# Recall Bulletin

**SUBJECT:** Transmission Shift Cable Fracture

**MODELS:** 2004-2007 Chevrolet Malibu Maxx  
2004-2008 Chevrolet Malibu  
2005-2008 Pontiac G6  
2007-2008 Saturn AURA  
Equipped with 4-Speed Automatic Transmission (ME7/MN5)

1765068

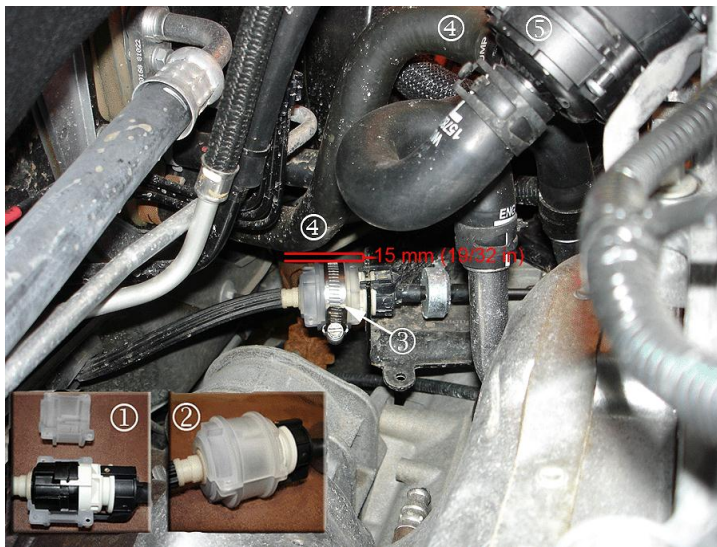
1. Remove and discard the floor shift control cable. Refer to *Floor Shift Control Cable Replacement* in SI.

2. Remove and discard the shift cable bracket (4) attached to the transmission.
3. Install a new floor shift control cable and new bracket. Refer to *Floor Shift Control Cable Replacement* in SI.
